TECHNICAL MEMORANDUM

RE: Response to Comments on Remedial Investigation Checklist
Meeker Former Gas Station Site
105 Washington Ave N., Kent, WA
Cleanup Site ID: 2782
Facility/Site ID: 44681713
VCP Project ID: NW3167

(Image Source: RI/FS/CAP, September 1, 2017)

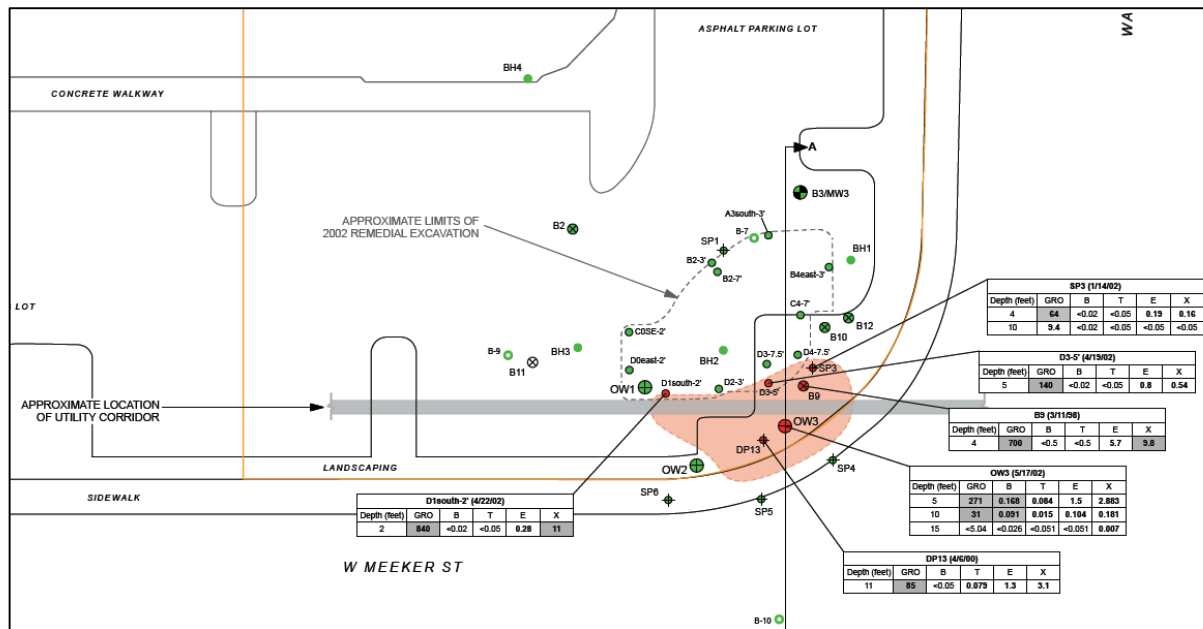
Ecology comment regarding Site Characterization (RI Checklist page 1):

The site may not be adequately characterized due to off-site contamination and possible contamination in utility corridor. Need additional information in this area.

EPI believes that the Site is sufficiently characterized. All contaminated soil was removed to the maximum extent practicable in 2002. After the soil removal, sampling was performed at all possible locations. The following image illustrates the area of contaminated soil that was removed in 2002 and all post-excavation sampling locations.

The sampling locations were selected based on existing data and were limited by the presence of dense utilities, natural gas lines, and other buried infrastructure associated with the major arterial intersection, including traffic-related sensors beneath the adjacent roadway to the east. As illustrated in the above image, the off-site extent of remaining impacted media is well defined to the south and southeast and no additional characterization is possible or necessary. EPI would like to discuss any perceived data gaps with the Ecology Site Manager, when assigned.
